New High School in Bungendore

State Significant
Development Application
(SSD-14394209)

Architectural + Landscape Design Report Addendum

Rev B
September 2022
Project No. 200096

10 Revised Materiality

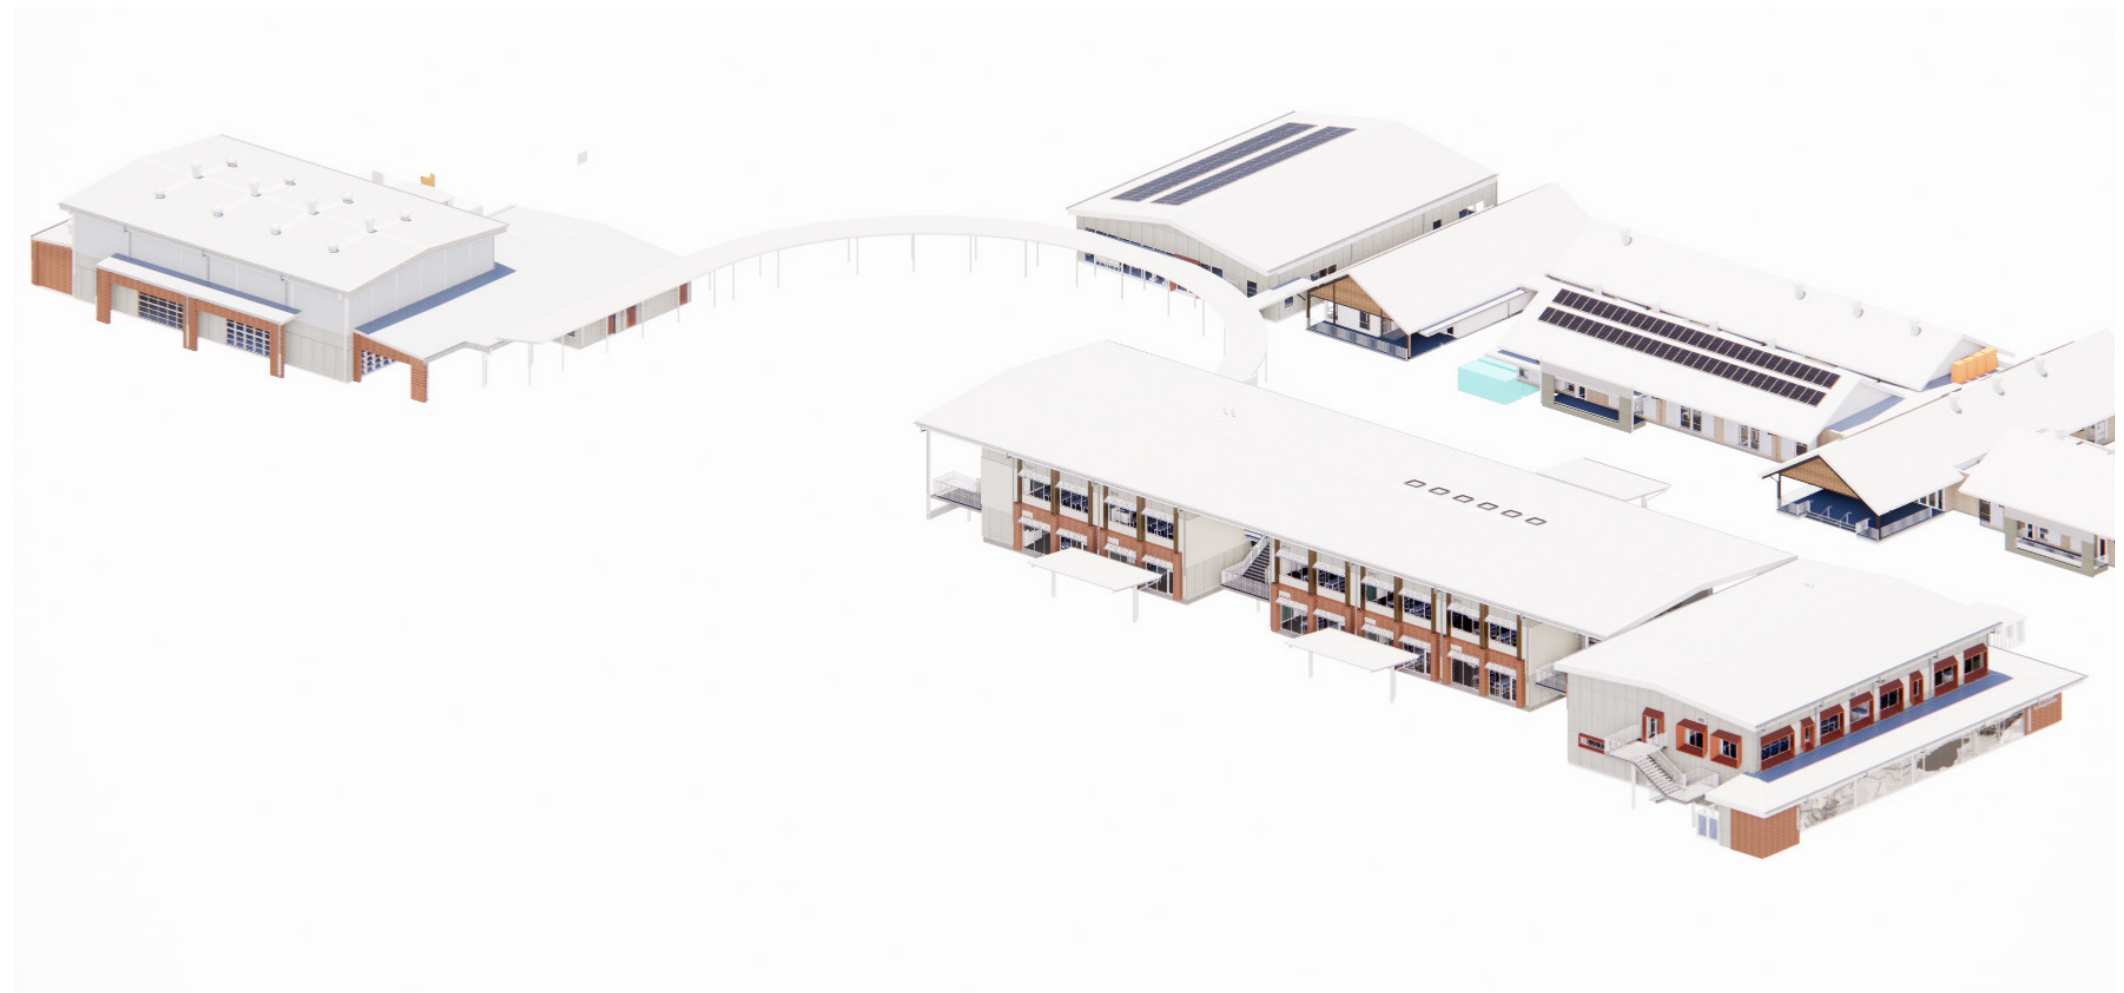
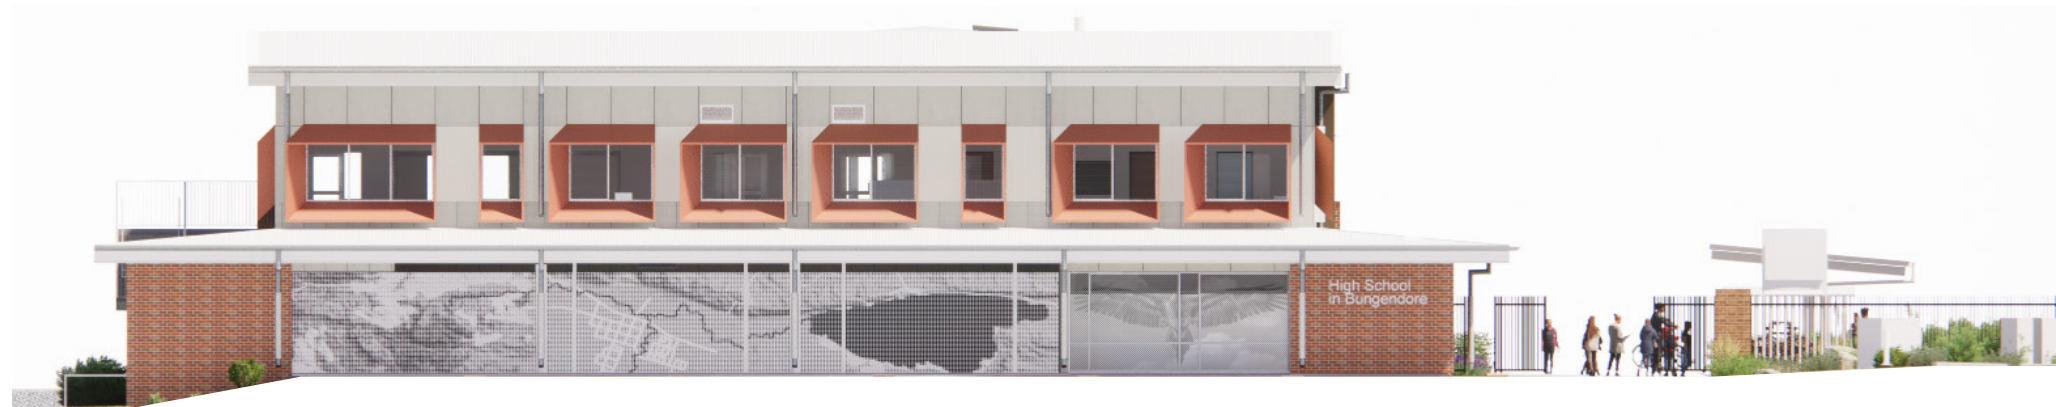
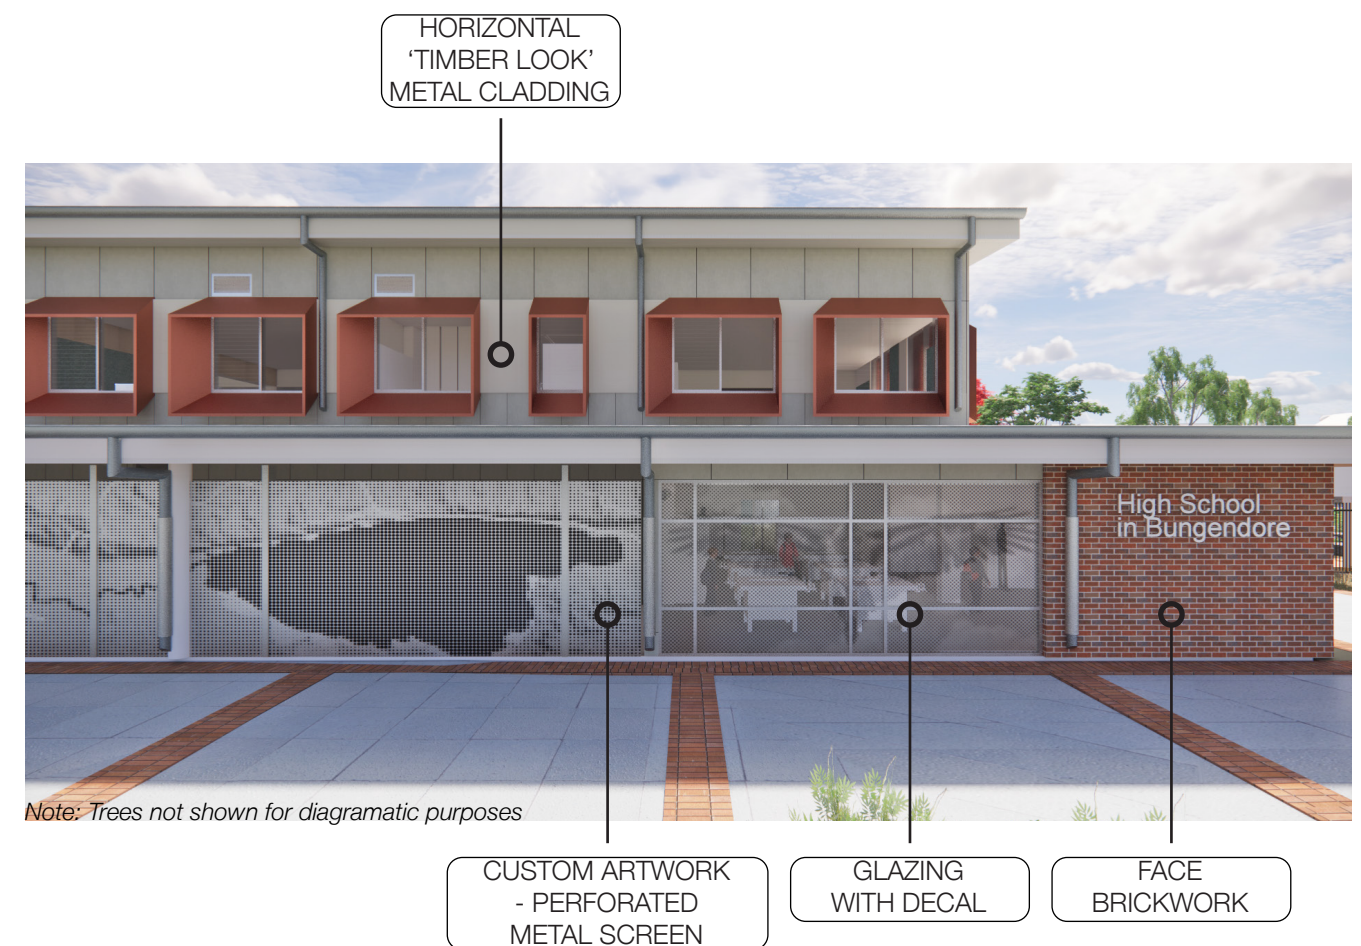
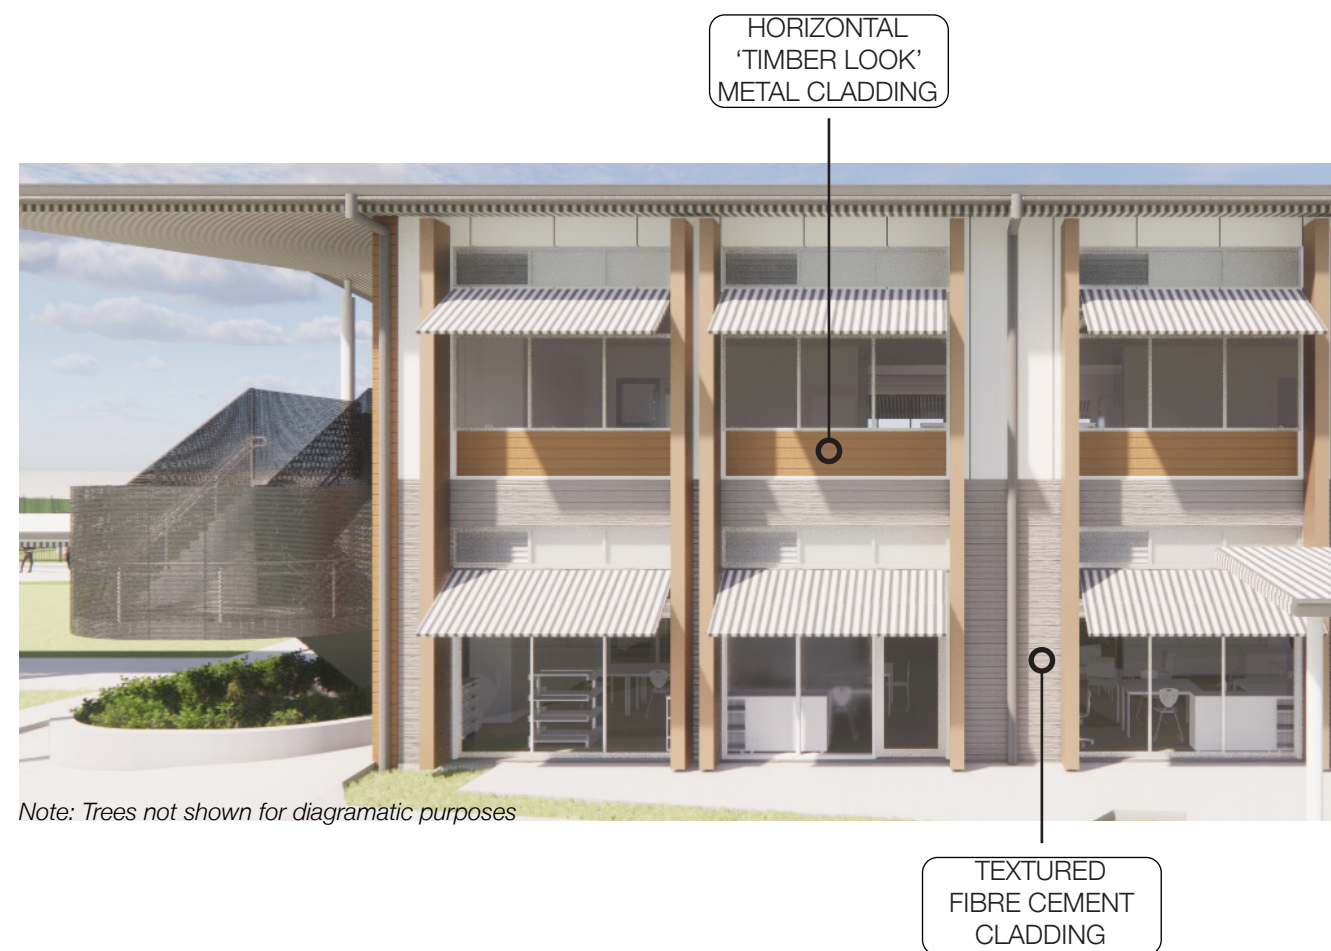
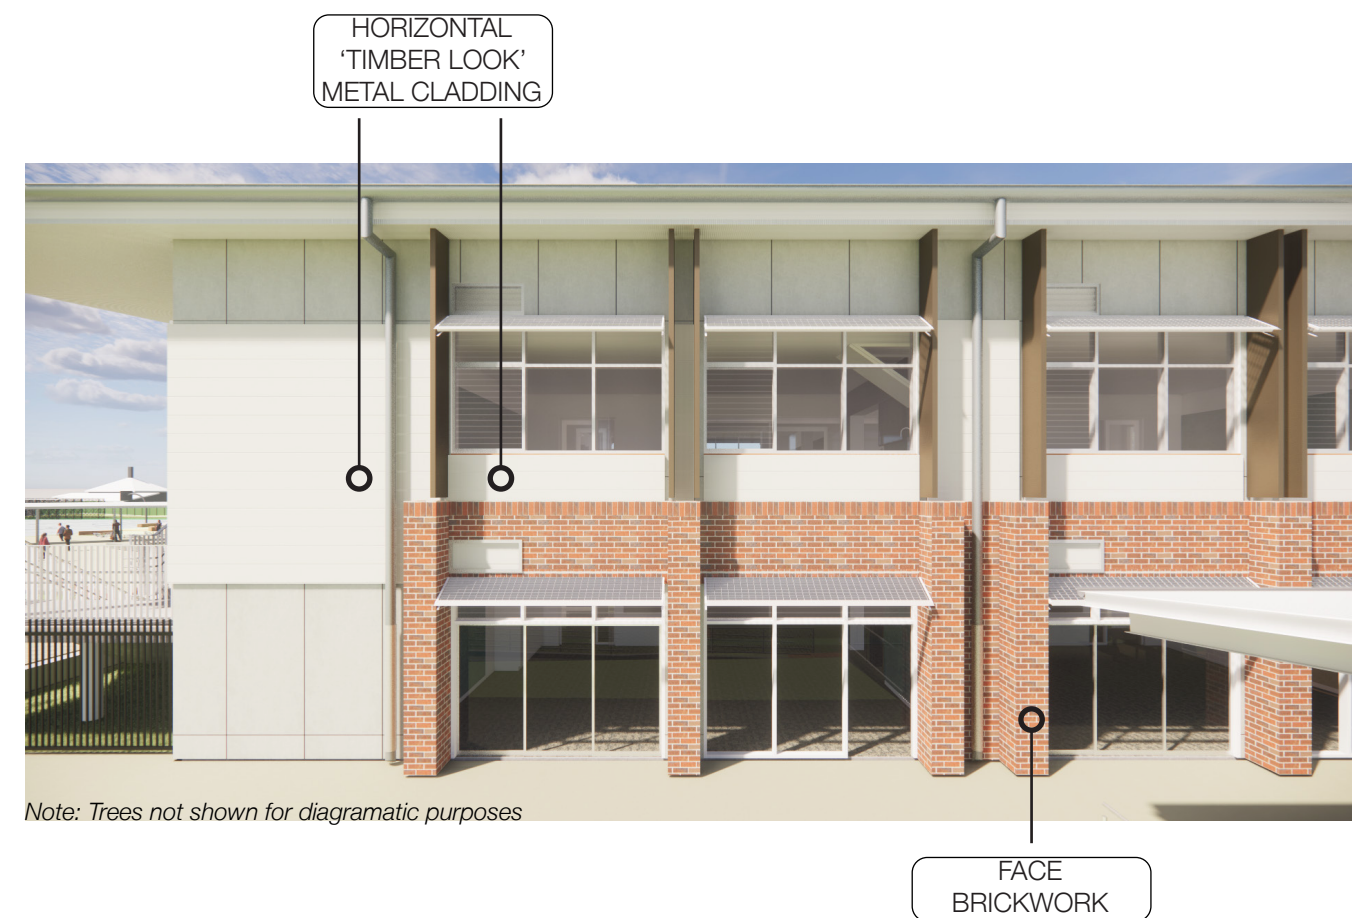
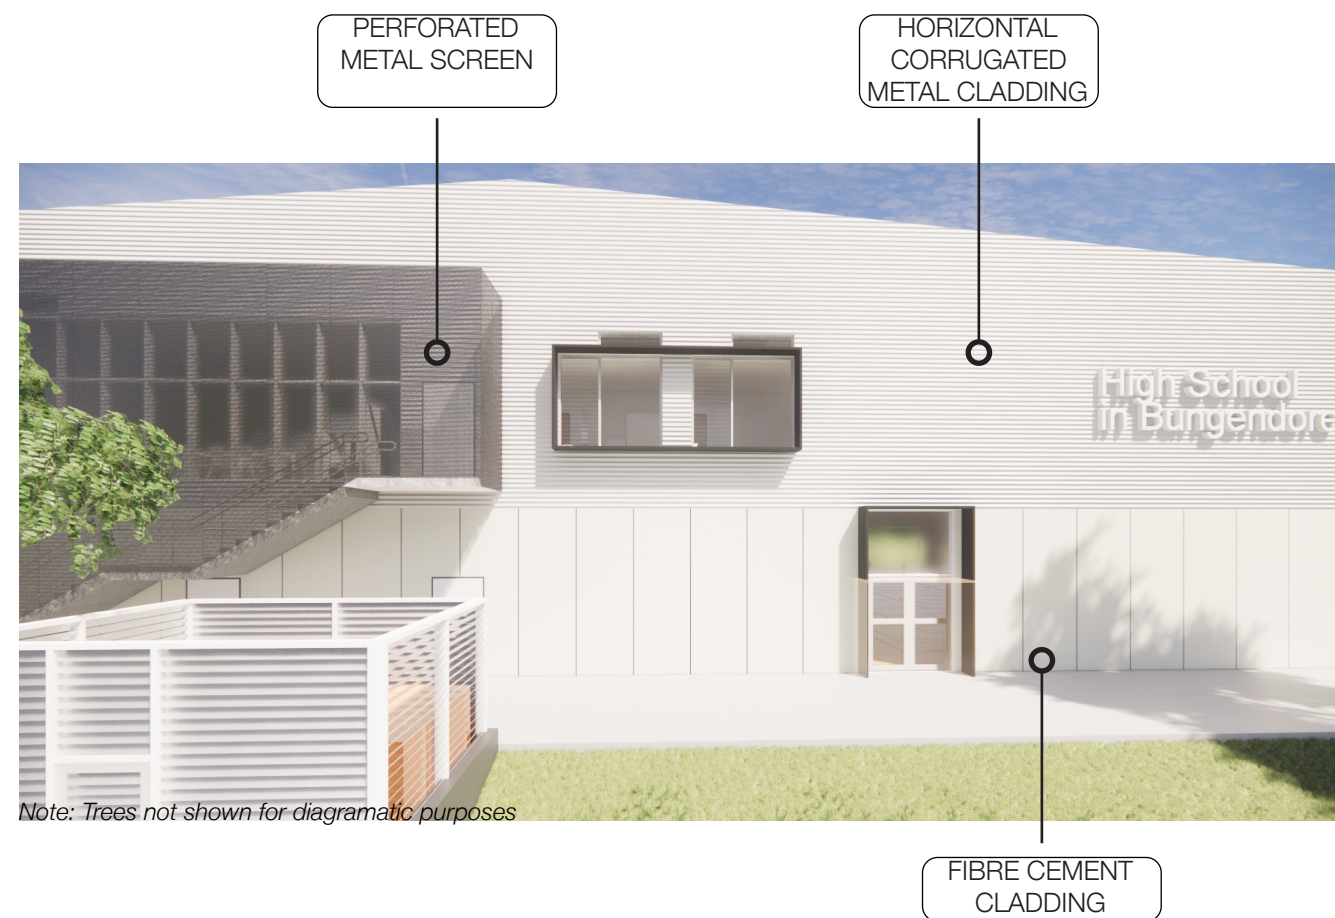
The façade materials of the proposed buildings have been revised to complement the existing village character as follows:

Face brickwork has been introduced at ground level to the public facing facades of Gibraltar Street, Mick Sherd Oval and Turallo Terrace, as well as framing the new covered walkthrough of Block B from the School Avenue side. The use of brick responds to the traditional aesthetic of a solid base and lightweight upper storey; provides depth to the facades; and creates an improved civic quality that relates through materiality to the historic buildings within the town.

Light coloured, horizontal metal plank cladding has been introduced at first floor level to be suggestive of horizontal painted weatherboard cladding, while meeting NSW Education's durability and maintenance requirements.

Corrugated metal walling has been retained to the high-level walling of Block D and to Block F, located on the Agricultural Plot.

Corrugated metal roofing is proposed to each of the new buildings.

The built form of Blocks A and D have been revised to introduce a lower roof form that wraps around the buildings, providing a sympathetic form that relates the local verandah vernacular and reduces the scale of the buildings.
